REQUEST FOR COUNCIL ACTION

AGENDA SECTION: PUBLIC HEARINGS	ORIGINATING DEPT: PLANNING	ITEM NO. E-10
ITEM DESCRIPTION: Preliminary Plat #02-62 by Leslie Lurken to be known as Wedgewood Hills 6 th . The applicant is proposing to subdivide approximately 6.68 acres of land into 25 lots for single family development and one Outlot. The plat also proposes to dedicate right-of-way for two public roads. The property is located along the south of Duvall Street NW and allows for the continuation of 54 th Avenue NW.		PREPARED BY: Theresa Fogarty, Planner

RE: Preliminary Plat #02-62 by Leslie Lurken to be known as Wedgewood Hills 6th. The applicant is proposing to subdivide approximately 6.68 acres of land into 25 lots for single family development and one Outlot. The plat also proposes to dedicate right-of-way for two public roads. The property is located along the south of Duvall Street NW and allows for the continuation of 54th Avenue NW.

DATE: December 31, 2002
TO: Jennifer Garness
Planning
RE: Wedgewood Hills 6th
Preliminary Plat #02-62

Proposed Preliminary Plat
Wedgewood Hills 6th

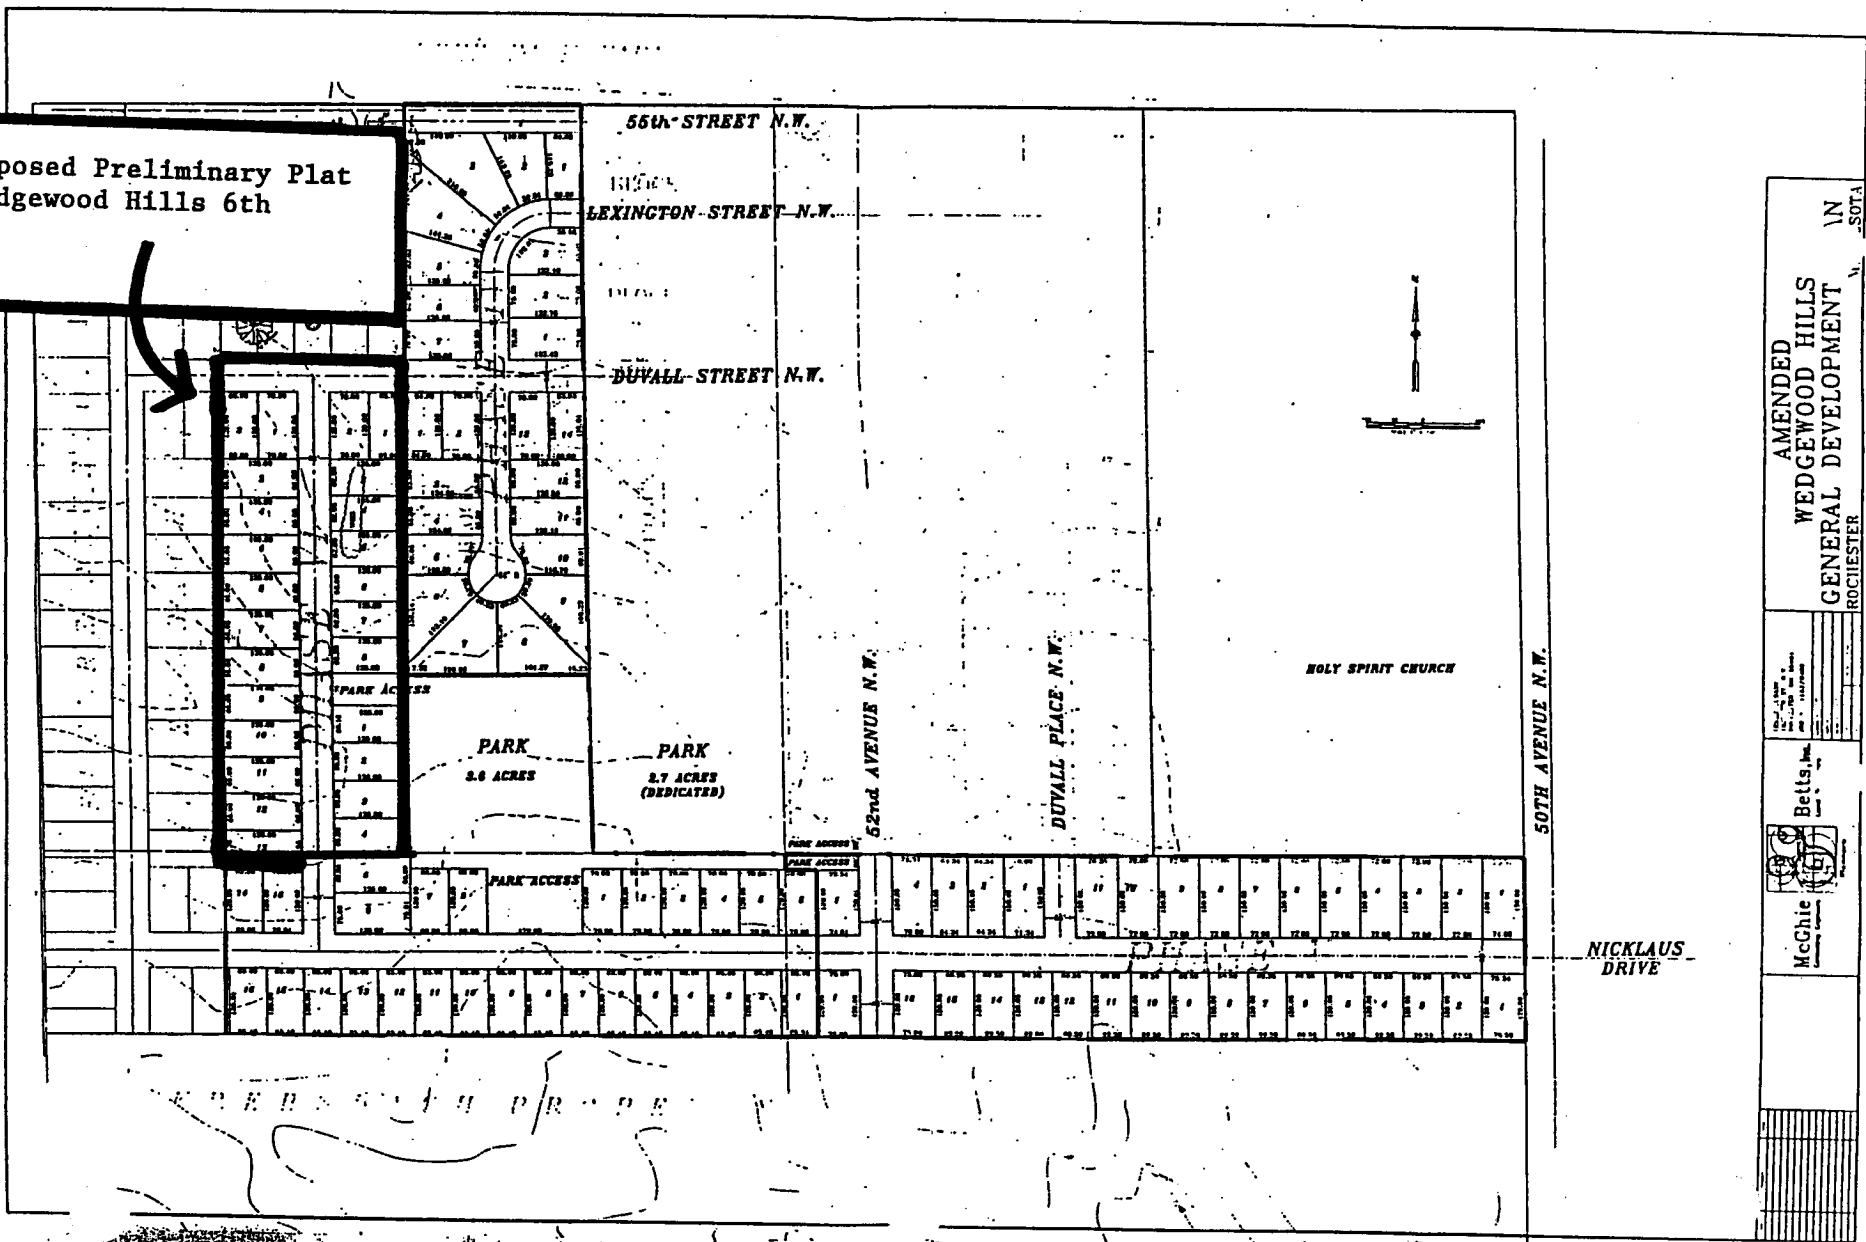
Section 64.227 of the Land Development Manual requires the dedication of trails needed to maintain connectivity between and through subdivisions under the following circumstance "Across any block exceeding 800 feet in length. According to the proposed preliminary plat, Block 1 exceeds the 800 feet in length. A mid-block connection (30' wide outlot) is required providing connection from the currently unplatted land located west of this plat. Staff is suggesting that the mid-block connection be placed between Lots 5 & 6, Block 1. The mid-block connection shall be dedicated to the City as an outlot, with the pedestrian path links constructed at the Developer's expense, concurrent with construction through the City-Owner Contract process.

- a. ***Provide a 30' outlot consistent with Section 64.227 of the Rochester Zoning Ordinance and Land Development Manual providing connection from the currently unplatted land located west of this plat. Staff is suggesting that the mid-block connection be placed between Lots 5 & 6, Block 1. The mid-block connection shall be dedicated to the City, with the pedestrian path links constructed at the Developer's expense, concurrent with construction through the City-Owner Contract process.***
